# STATEMENT OF ENVIRONMENTAL EFFECTS

## S4.55(2) MODIFICATION APPLICATION RESIDENTIAL FLAT BUILDING 96 NORTH STEYNE, MANLY

Figure 2: s4.55 Ground Floor (amendment in orange clouds + text); Squillace, September 2022

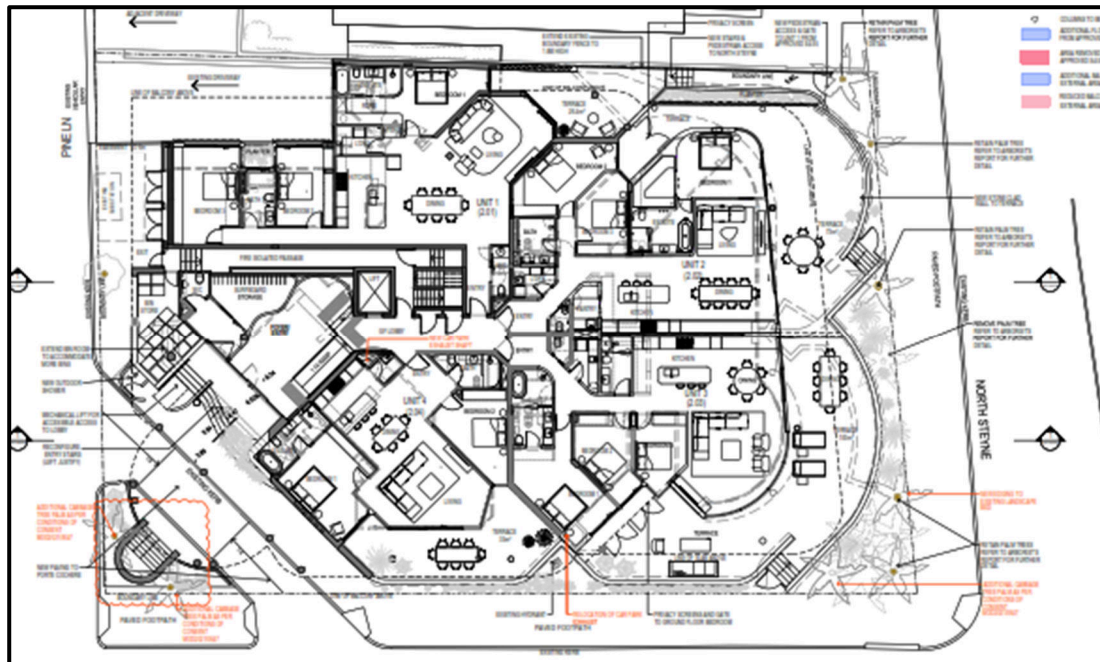
#### **Ground Floor (Unit 1, 2, 3, & 4)**

- New car park exhaust shaft
- Glass balustrades added to terrace/boundary wall (dwg 3007)

Figure 3: s4.55 Level 1 & 2; (amendment in orange clouds + text); Squillace, September 2022

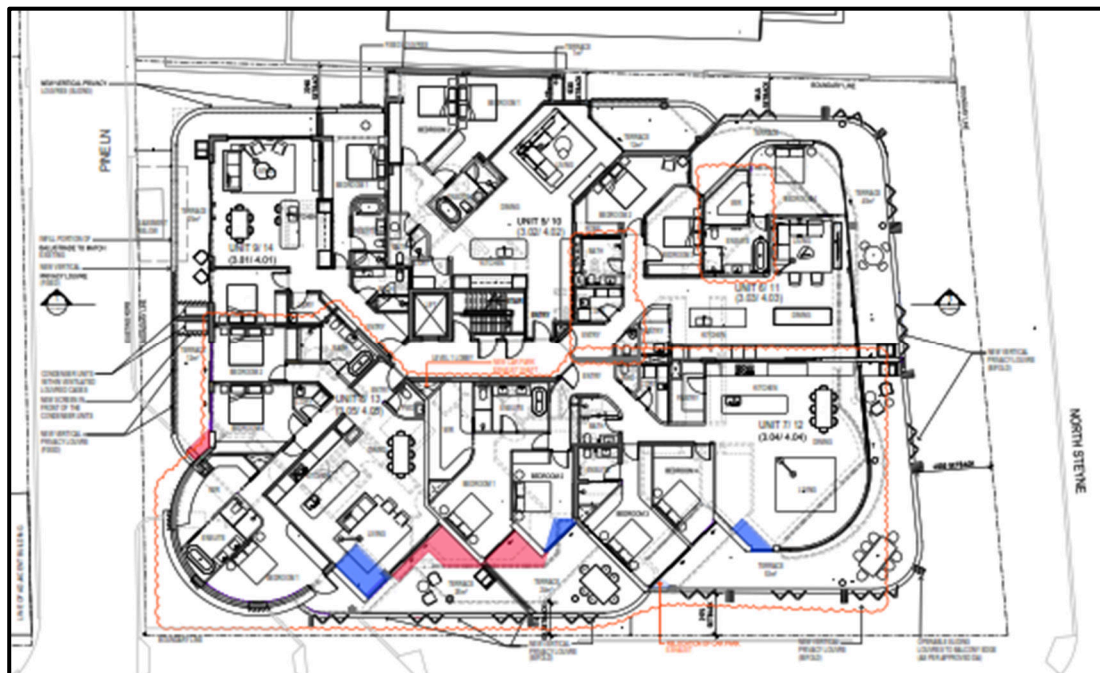
#### **Level 1 (Unit 5, 6, 7, 8, & 9) & Level 2 (Unit 10, 11, 12, 13, & 14)**

- Merge 3 into 2 units on Level 1 & 2 (22 units reduced to 20)
- Reconfigure southern units post-merger.
- Unit 7 & 12: relocation of car park exhaust
- Unit 8 & 13: new car park exhaust shaft
- Unit 6 & 11: reconfigure entry and bathroom
- Unit 6 & 11: reconfigure WIR n ensuite
- Minor additions and reductions to terraces of merged southern units (shown red and blue on s4.55 plan set)

Figure 4: s4.55 Level 3 Floor Plan; (amendment in orange clouds + text); Squillace, September 2022

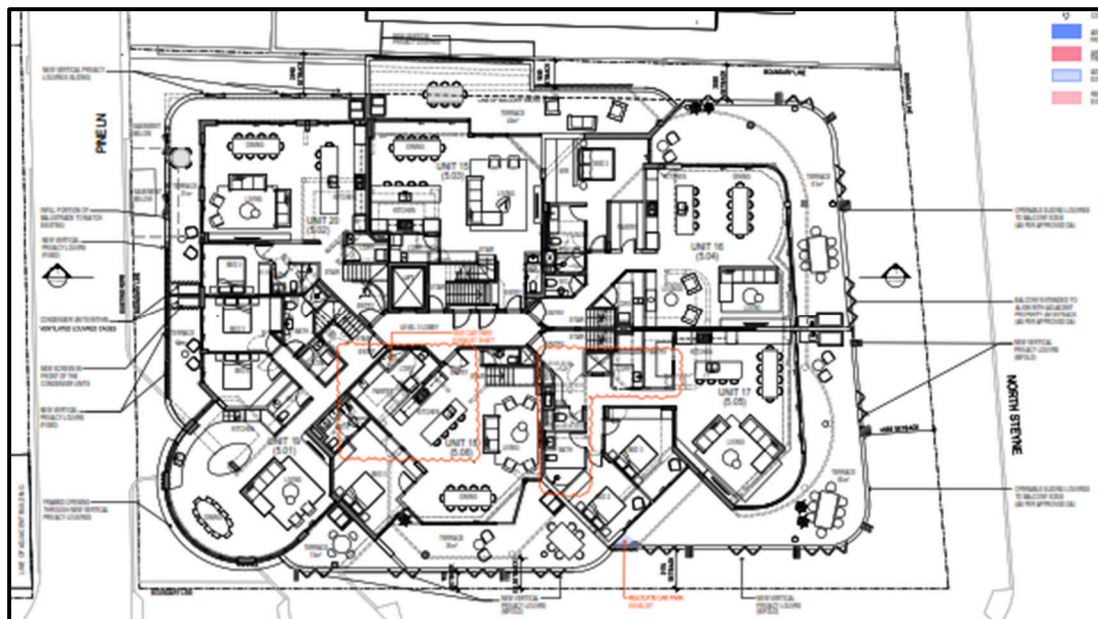
#### **Level 3: (Unit 15, 16, 17, 18, 19 & 20)**

- Unit 17: relocation of car park exhaust; internal lift + reconfigure internal layout
- Unit 18: reconfigure entry, kitchen, laundry and pantry areas

Figure 5: Level 4 Floor Plan; (amendment in orange clouds + text); Squillace, September 2022

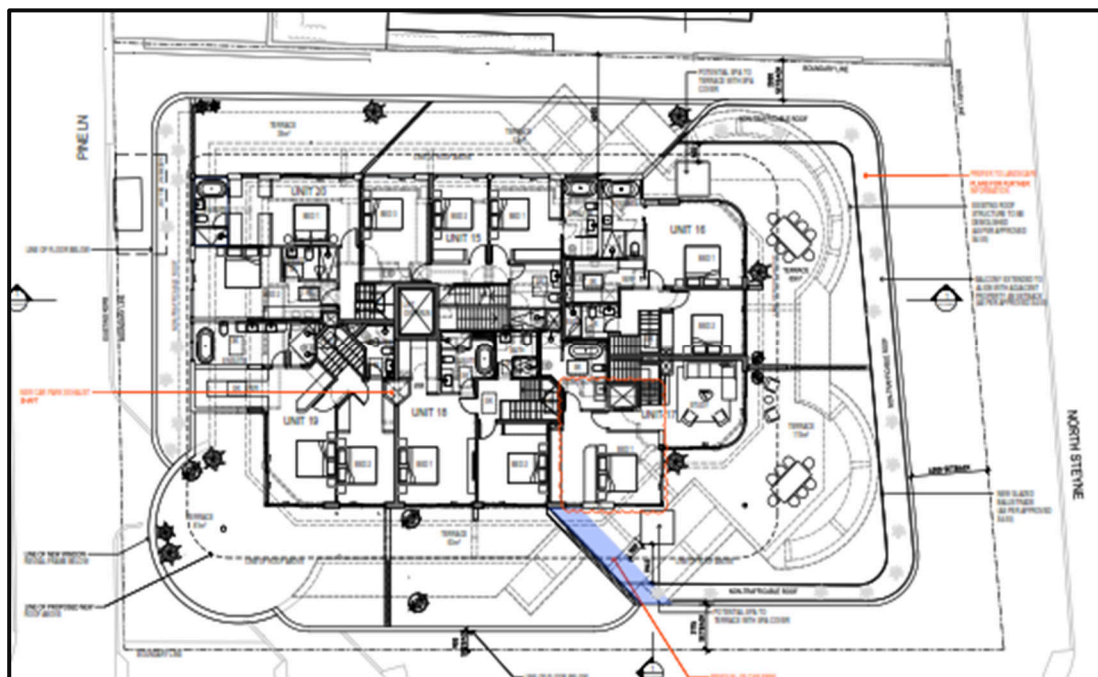
#### **Level 4: (Upper level of Unit 15, 16, 17, 18, 19 & 20)**

- Units 17: removal of car park exhaust
- Unit 17: reconfigure Bedroom 1 + internal lift
- Unit 18/19: new car park exhaust
- Succulents added to non-trafficable areas

Figure 6: s4.55 Roof Plan; (amendment in orange clouds + text); Squillace, September 2022

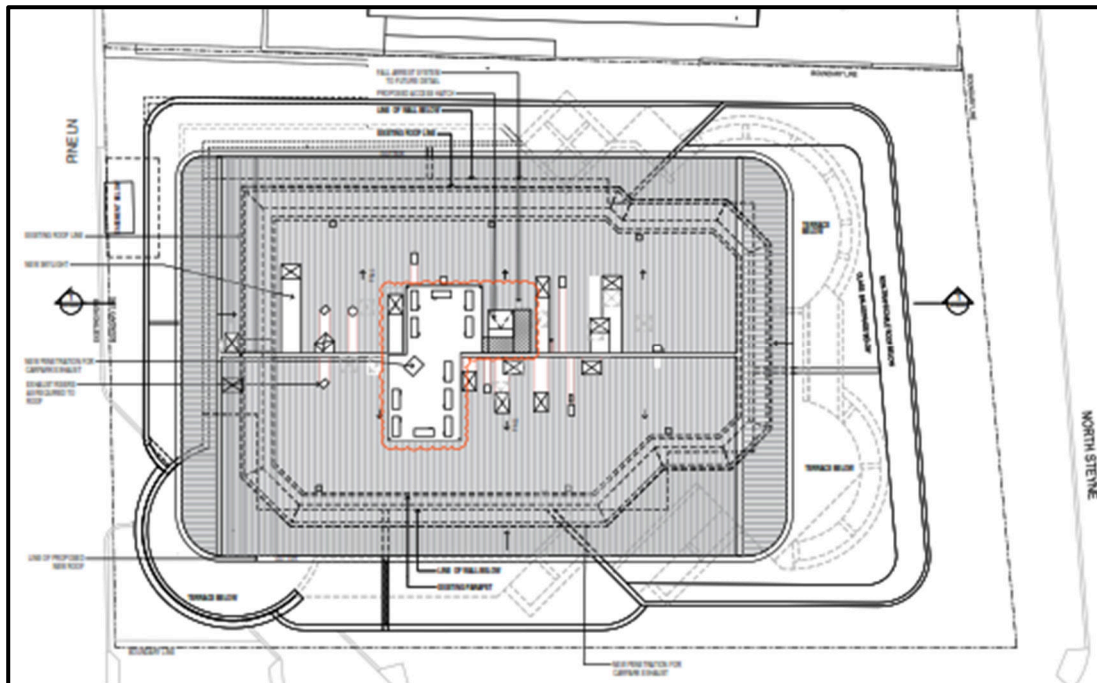
**Roof:**

- New penetration of roof for car park exhaust above Unit 18/19
- Approved access hatch for servicing relocated (as per roof plan)
- Roof plant area reduced
